TN022 – Sonnen eco 8.0 Product Upgrade to Wider Cabinets

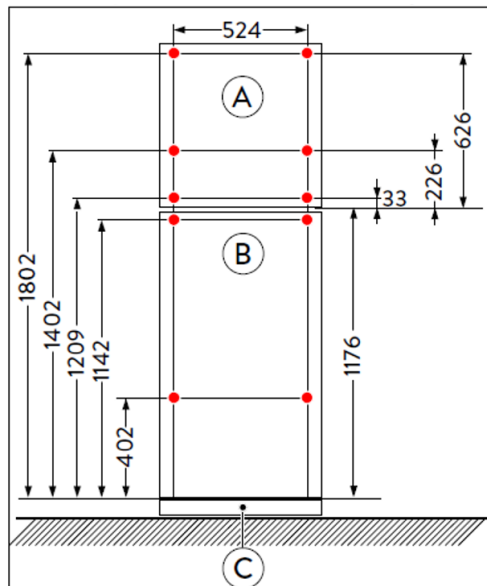
The width of the sonnen eco 8 series products is to become wider by approximately 3cm to aid the installation and servicing of the battery modules.

This dimensional change will affect both the main (top) unit as well as the lower battery extension housing.

Normal System Dimensions

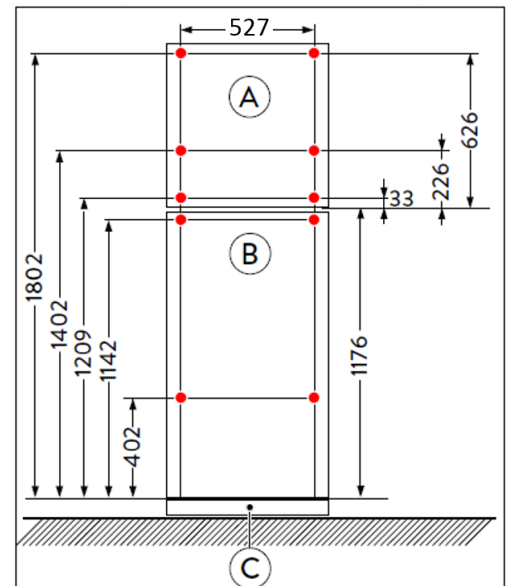
Using a combination of normal and wider system components is not possible due to weight distribution and the alignment of cable access. Please ensure that system components supplied are of the same width dimension.
